VILLAGE OF SUSSEX
SUSSEX, WISCONSIN

Minutes of the Architectural Review Board (ARB) meeting held on August 3, 2016.

MEMORANDUM

RE: ARB meeting for August 3, 2016

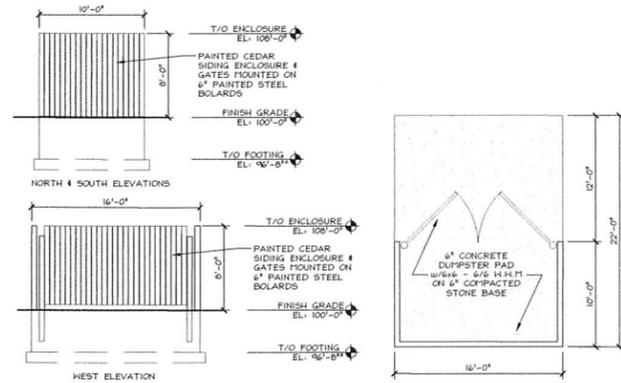
This site is zoned B-4. The plantings around the buildings and within the complex are sufficient. The location of the fence on the east side of the property screening the buildings and residential homes is not clear, the presenter will need to explain the location and provide details about the type of fence to be used.

The Village Engineer has concerns about the type and location of the plantings located near the pond.

- Provide a plan detailing the fence and the location of the fence along the property line.
- Subject to review by the Village Engineer.

1 PROPOSED SITE PLAN
SCALE: 1" = 20'-0"

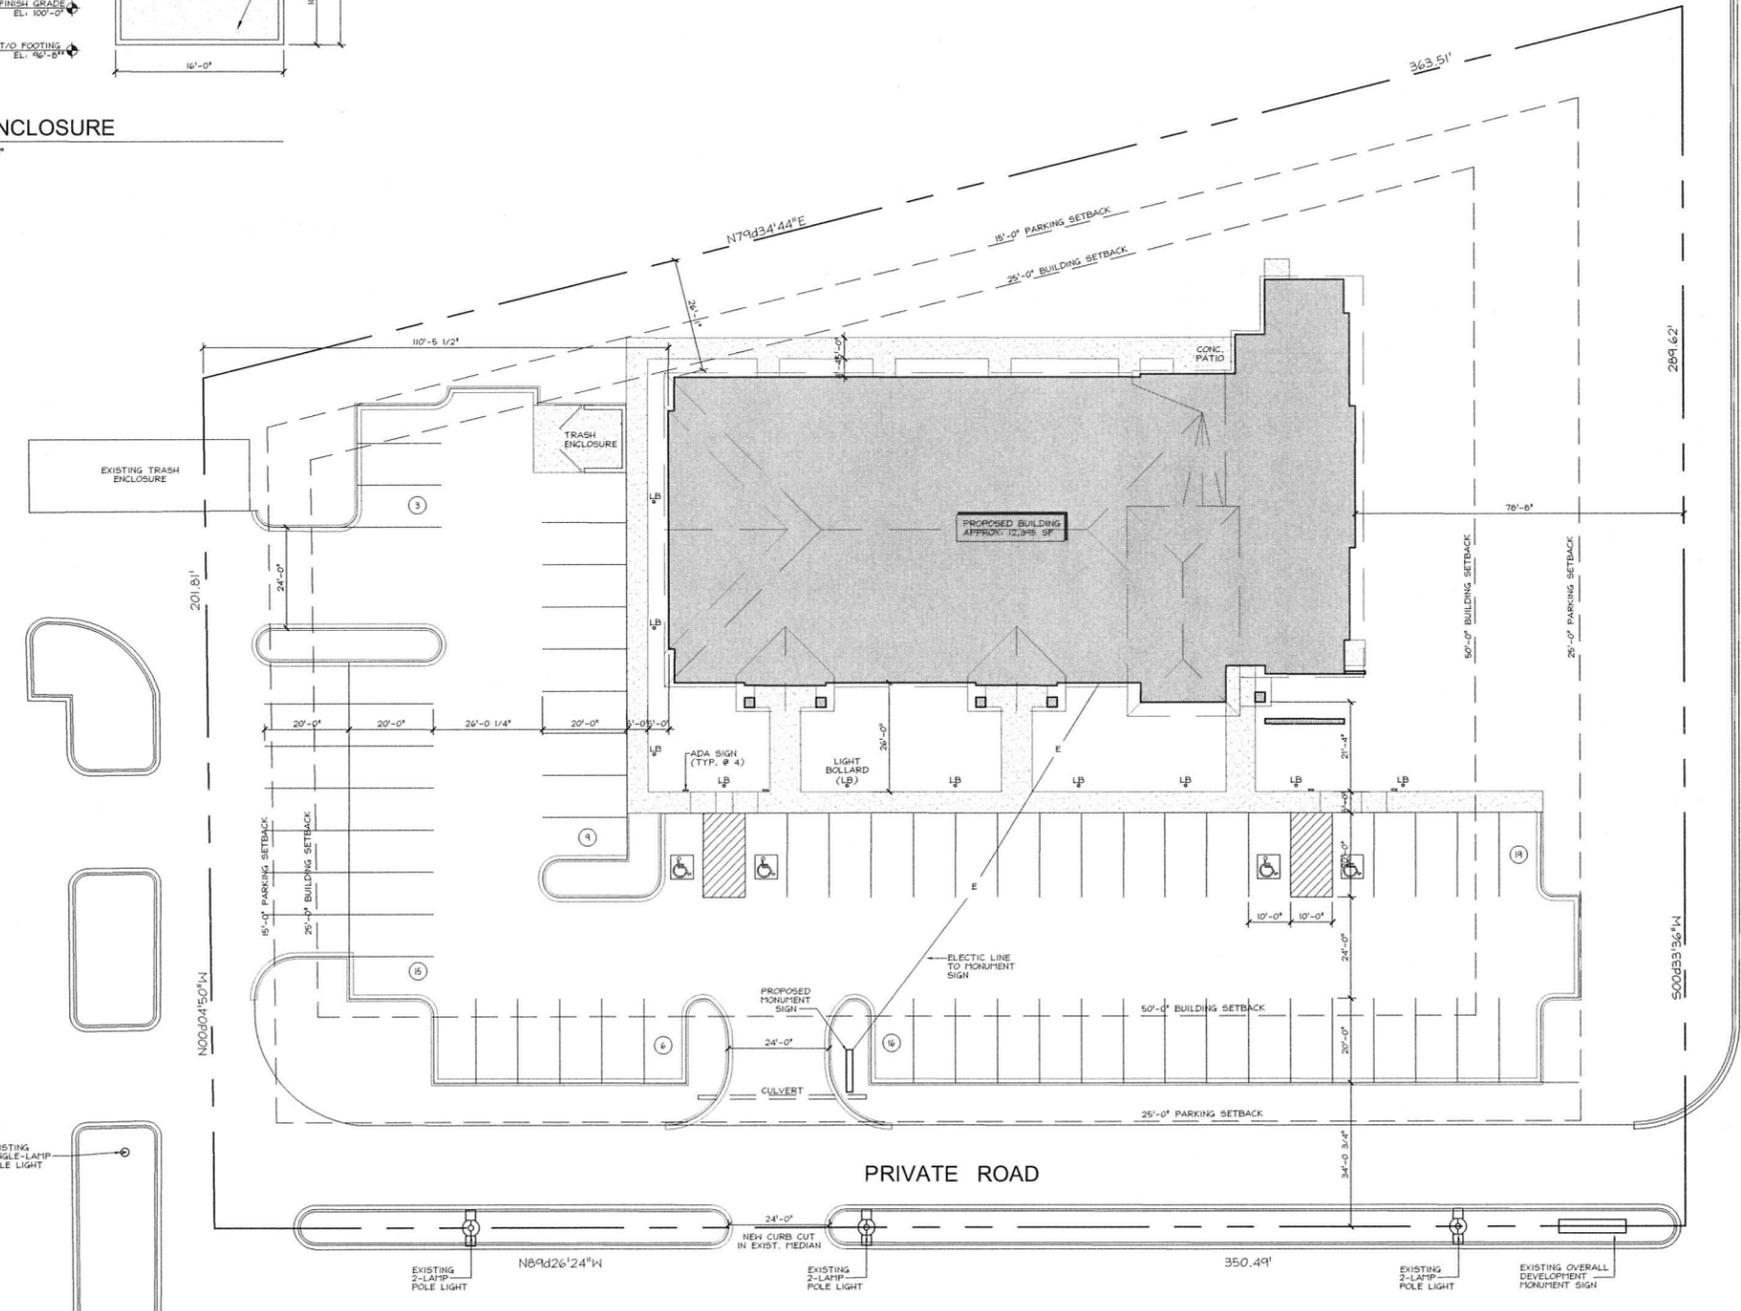
- Has sufficient parking with 68 stalls and safe pedestrian orientation.
- Subject to final review by the Village Engineer.

Northwest Perspective

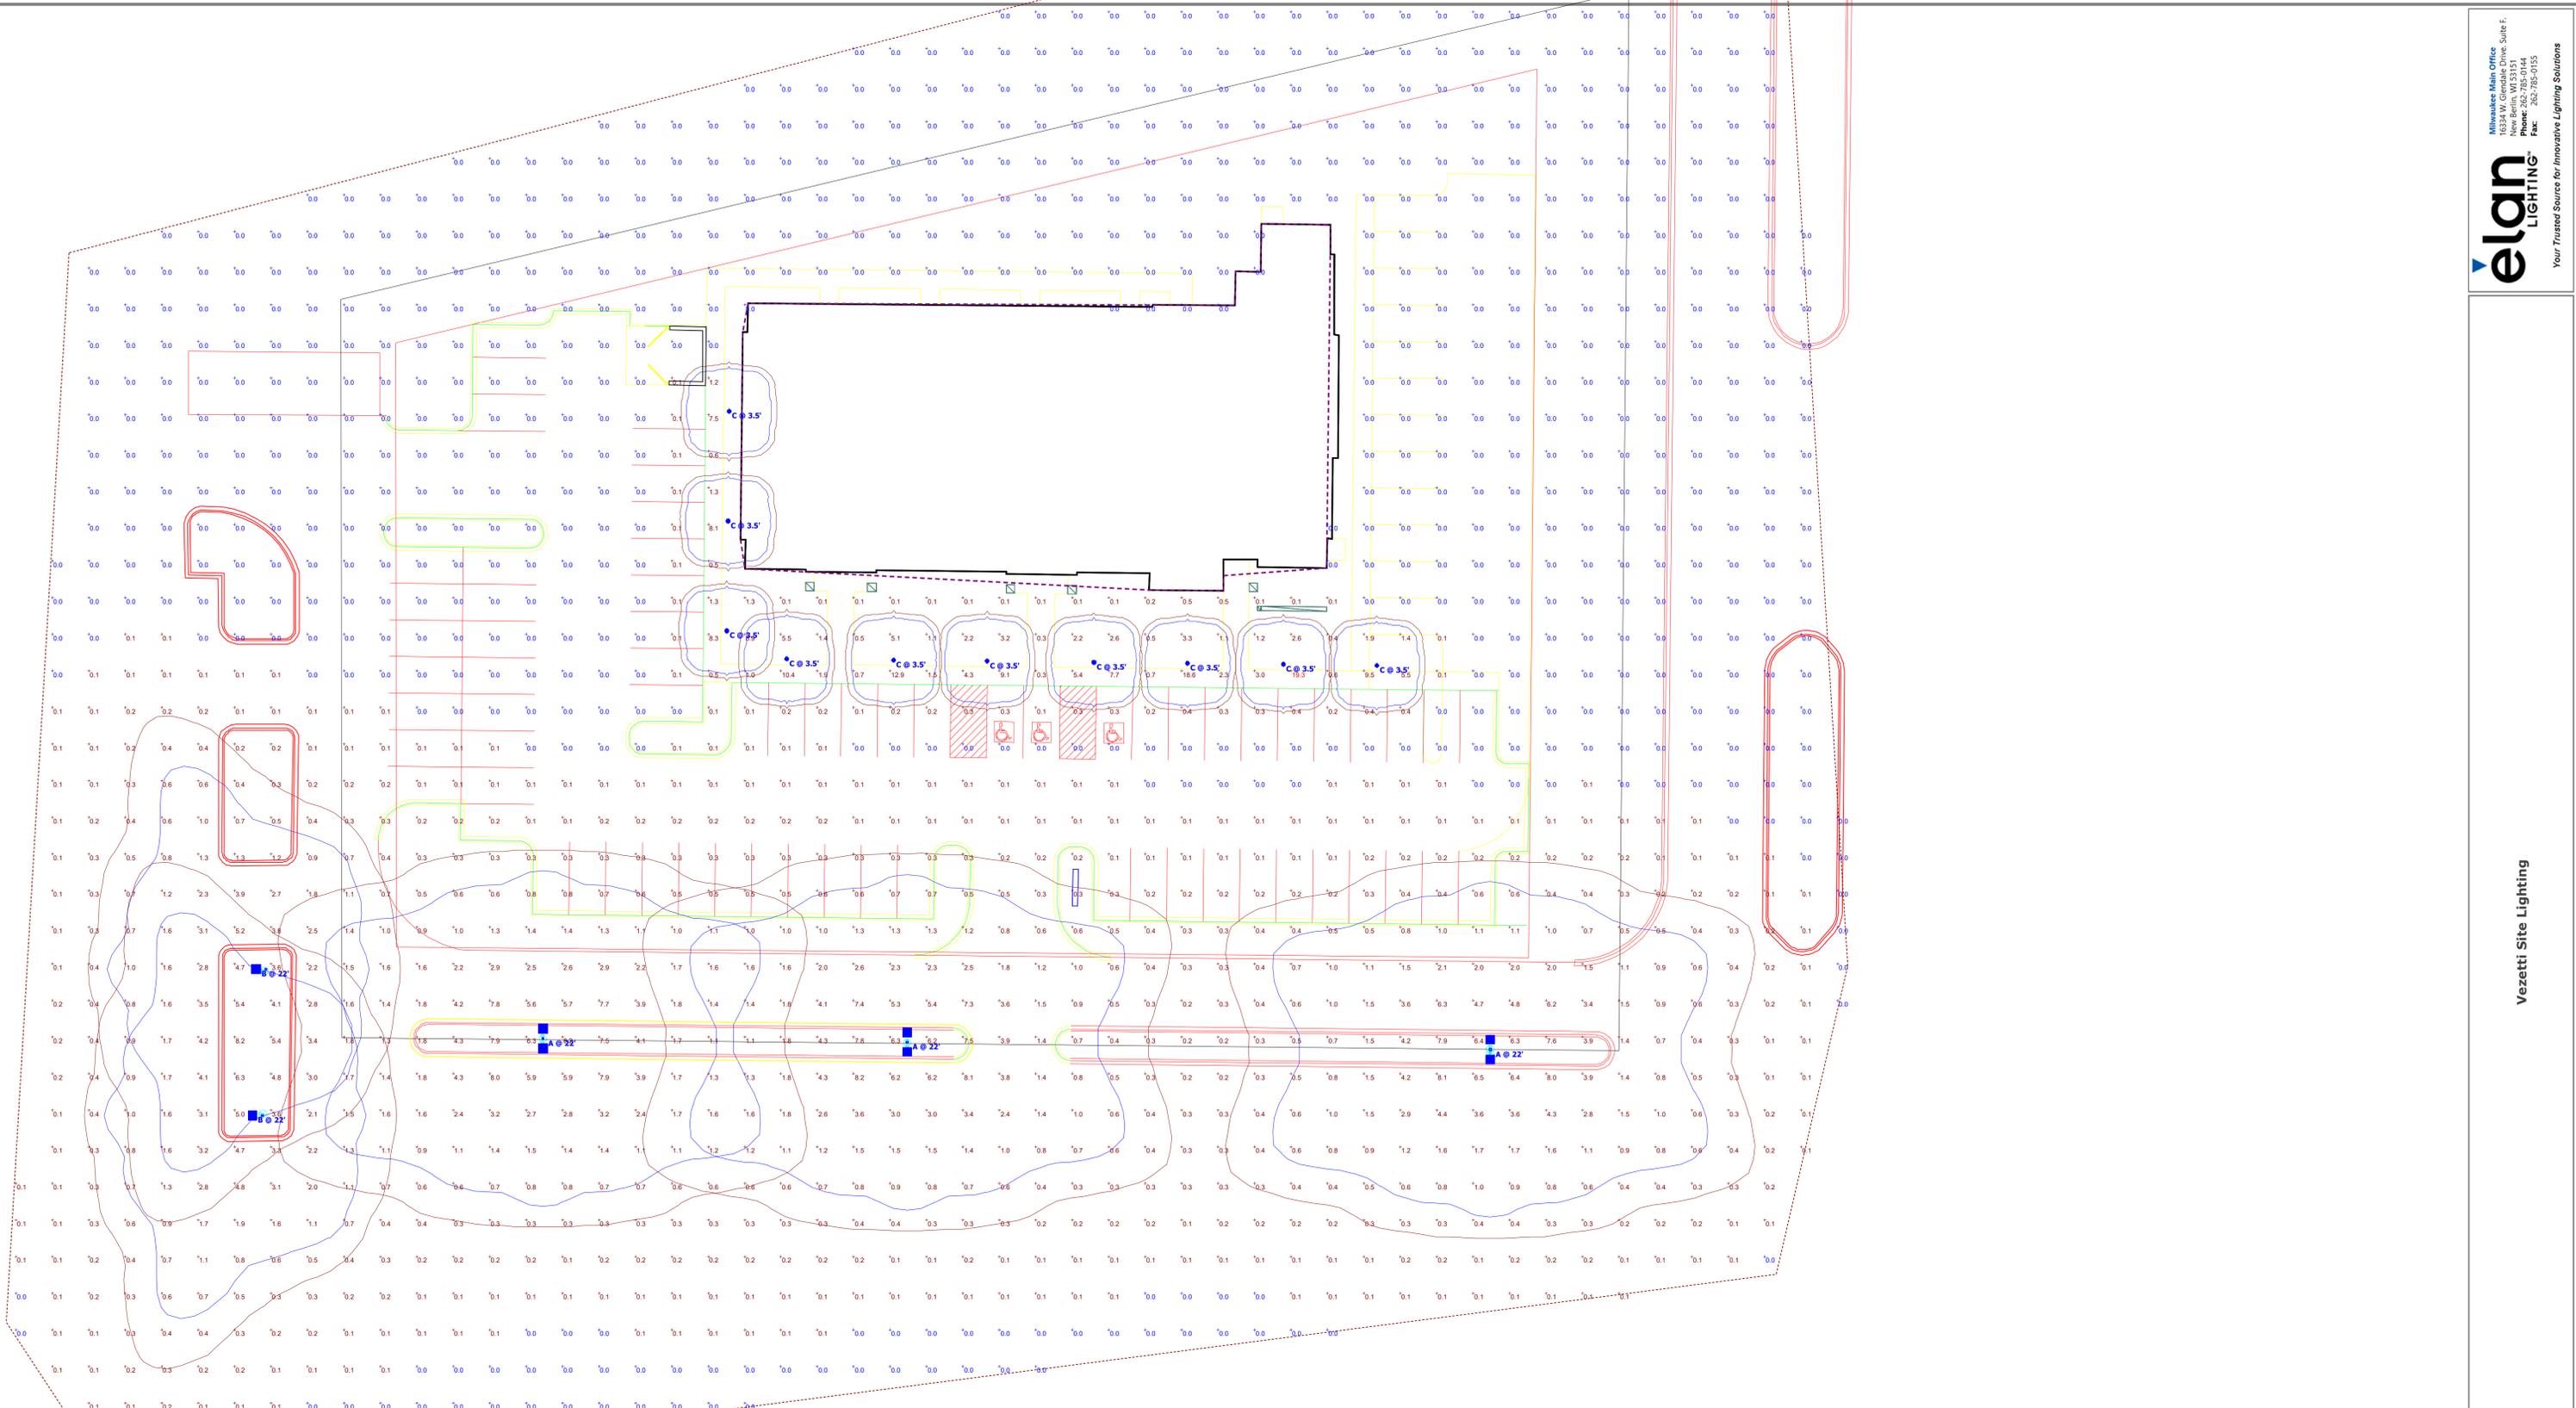
Mrs. Fluet stated the ARB would need to consider the metal roof and if it architecturally fits the design of the building. Mrs. Schauer asked for the reason of the metal roof just on that one elevation of the building. Mr. Hernandez stated because of the slope of the roof line. Mr. Hernandez provided a color sample of the metal roof (copy attached). It was the consensus of the ARB the metal roof fit the architecture of the building and it was in a limited area.
